# Service Advisory

W-143

Models Affected: LT 942G (13AX605G790), LT 946G (13AP606H790)

Subject: **UPPER TRANSMISSION DRIVE BELT PATH ALIGNMENT & CLEARANCE**

FIGURE 1

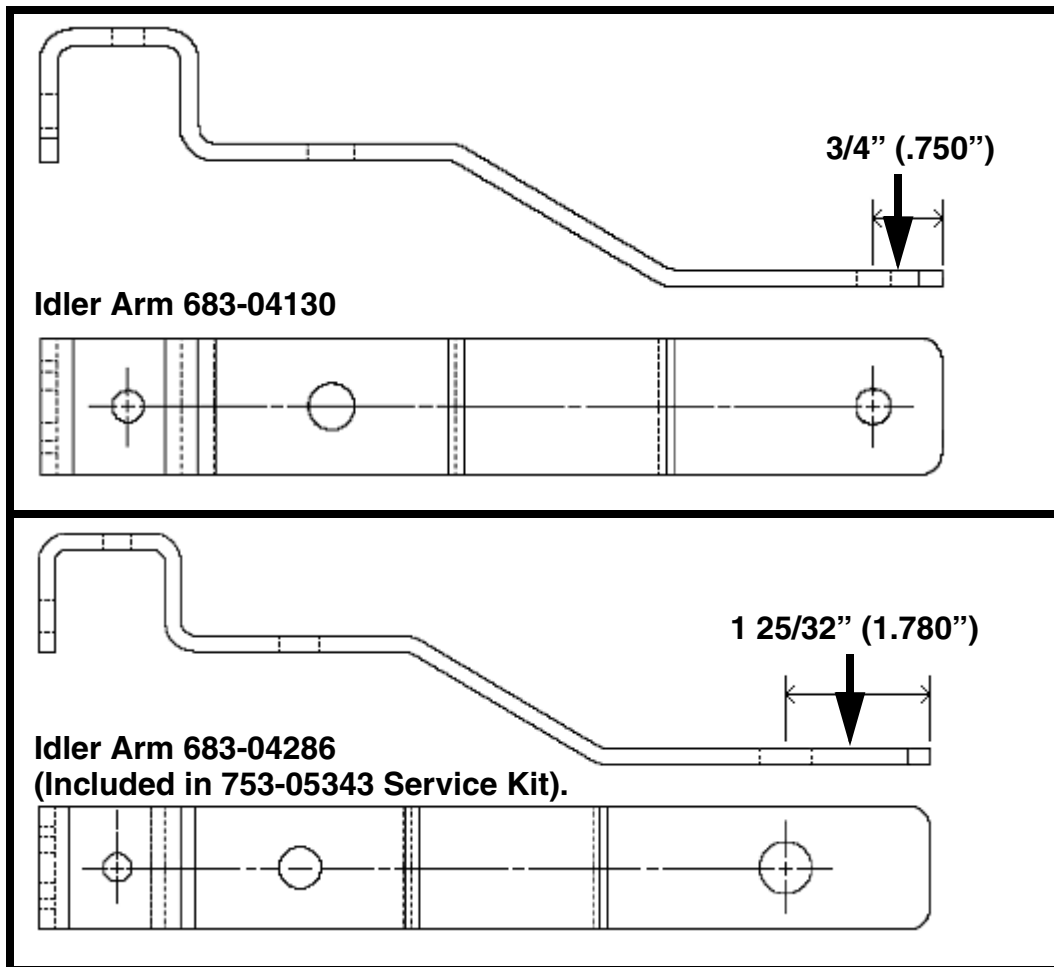
**#1.** The first issue is the transmission's upper drive belt will come off the tensioning idler pulley under certain operating conditions. This will result in the loss of drive & possible damage to the upper drive belt. This could be caused by the extension spring breaking or becoming unhooked. If the above occurs or the unit falls in the serial number range listed above order and install **Service Kit 753-05343**. If the Unit does not fall into the serial number range above & the above issue is present, compare the end of the idler bracket on the unit to the diagrams in figure 1. If the Idler arm measures  $3/4"$  (.750") from the center of the bolt pivot hole to the end of the idler arm & has a  $3/8"$  bolt for the pivot bolt, Install **Service Kit 753-05343**.

**PURPOSE:** This advisory is to notify dealers of **Service Kit 753-05343** which provides the latest transmission torque bracket & upper belt tensioning idler configuration. The new hardware reduces idler vertical movement providing an improved belt path alignment. The advisory also covers a possible clearance issue between frame & belt.

FIGURE 2

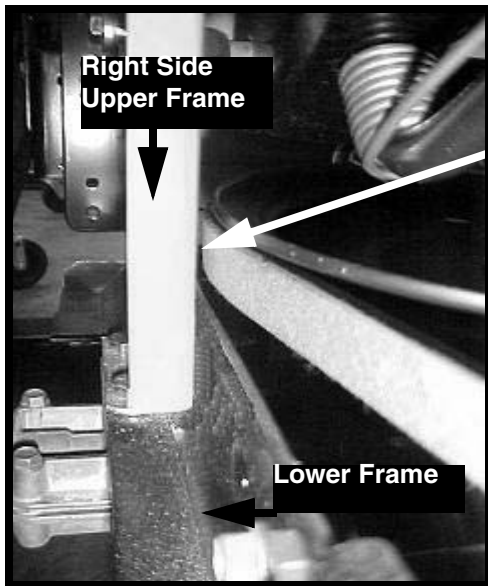
#2. The second issue is that the transmission's upper drive belt may wear excessively & break due to the belt & or transmission input pulley rubbing the right side of the upper frame. This may occur in some units.

Use a 736-0343 (.120"-.125") flat washer as a gauge to check the clearance between the upper right side frame & the transmission drive belt. If the 736-0343 flat washer is able to pass between the frame & the back side of the transmission drive belt, the clearance is good & no further action is required. Figure 2.

If the 736-0343 flat washer is unable to fit between the right side upper frame & the back side of the transmission drive belt, remove the forward most self tapping screw securing the right side upper frame to the lower frame. install the 736-0343 flat washer between the right side upper frame & the lower frame & reinstall the self tapping screw & tighten. Check clearance.

Slide 736-0343 Flat Washer Here To Check Clearance.
